# HALF-WAVE MERCURY-VAPOR RECTIFIER

8008

The 8008 is the same as the 872-A except for the following items:

92CM-6299R3

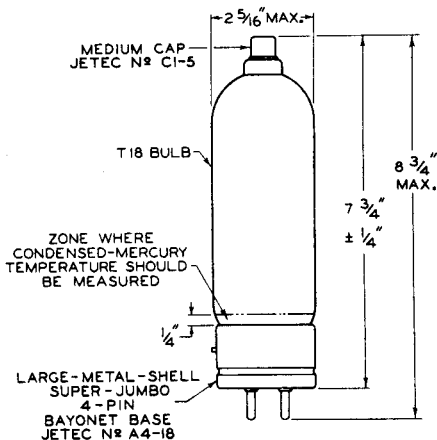
Maximum Overall Length . . . . .	8-3/4"	
Seated Length. . . . .	7-3/4" ± 1/4"	←
Weight (Approx.) . . . . .	6.8 oz	←
Base . . . . .	Large-Metal-Shell Super-Jumbo 4-Pin with Bayonet (JETEC No. A4-18)	←
Basing Designation for BOTTOM VIEW . . . . .	2P	←

← Indicates a change.
